ITEM 3

APPROVAL OF RESERVED MATTERS OF CHE/19/00088/OUT - ERECTION OF DETACHED DWELLING INCLUDING ACCESS AT LAND BETWEEN 34 AND 38 LAKE VIEW AVENUE, WALTON, CHESTERFIELD, S40 3DR FOR MR AND MRS LONG

Proposed elevations

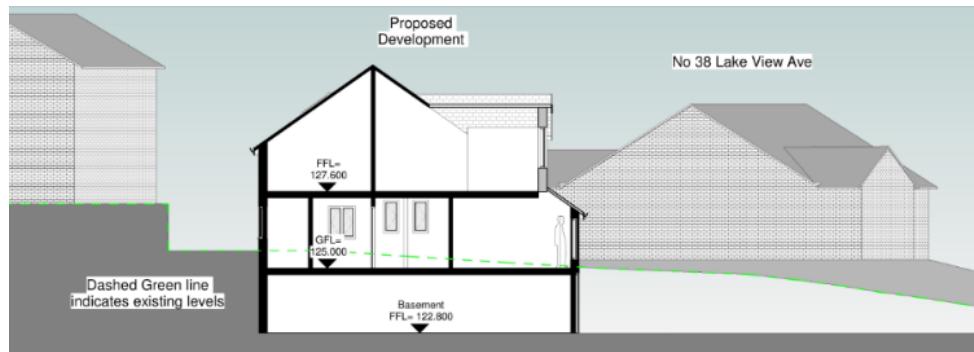
The proposed dwelling is set over three floors with a lower ground basement, and rooms within the roofspace. The proposal features two storey glazing with timber cladding and a pitched roof dormer to the principle elevation. Render is indicated to the remaining elevations.

- 5.5.5 Proposed materials incorporate timber cladding and indicate render to the remaining elevations. Render is not a feature of the surrounding streetscene and it is considered that render is not acceptable in this context. It is recommended that a condition be imposed requiring the submission of proposed materials for consideration and it is suggested that either a brick or stone should be specified to reflect the local vernacular.

2. This consent shall not extend to the use of render as shown on drawing PL_02 Revision C. Precise specifications or samples of all materials to be used in the construction of the external surfaces of the proposed development shall be submitted to and approved in writing by the local Planning Authority before any work to any external surface is carried out. The development shall thereafter be constructed in accordance with the approved details.

Sections of proposed dwelling

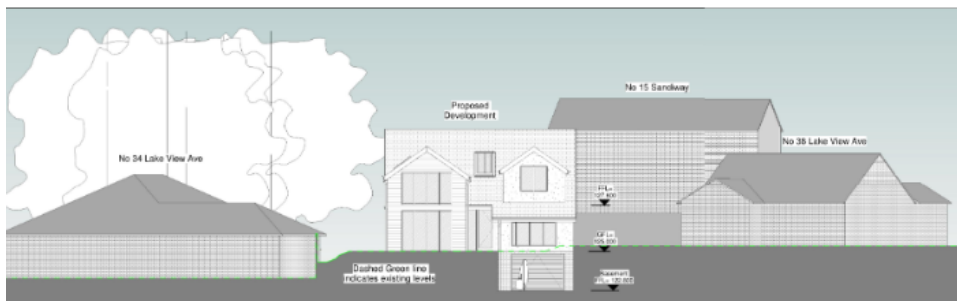
- 5.5.3 The surrounding streetscene is predominately characterised by single storey bungalows however a number have more than one living level (No 28, 32) and there is a two storey property visible in the immediate vicinity (No 47 and 15 Sandiway). As the proposed dwelling will be cut in to the sloping ground of the site to create a below ground basement level, it is acknowledged that the proposal will introduce a development which is two/three storeys in character.

Extracts of proposed site plan

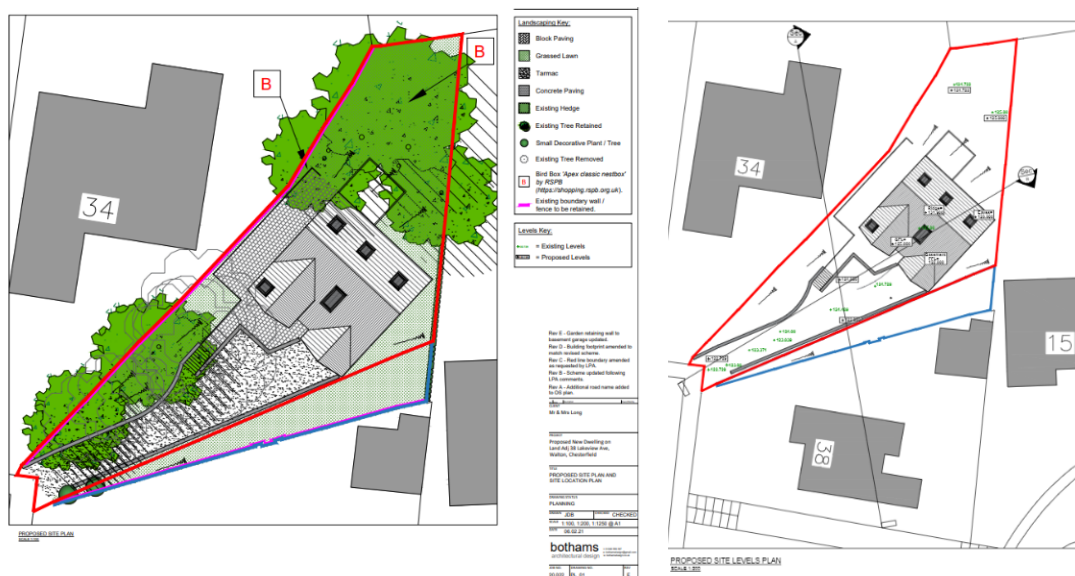
The proposal will provide an acceptable level private amenity space which exceeds the minimum recommendations as set out by the adopted Supplementary Planning Document ‘Successful Places’.

- 5.7.3 The proposed dwelling will be served by driveway parking and additional parking will be provided within the below ground basement. Revised plans have been submitted widening the access drive to provide opportunity for passing and for smaller vehicles to turn within the site and responds to the constraints of the site and narrow site frontage.

4. The biodiversity enhancements as set out on approved drawing 'proposed Site Plan', drawing number PL_01 Revision E for the installation of two bird boxes and one integral bat box shall be implemented in full prior to the occupation of the development and maintained thereafter.
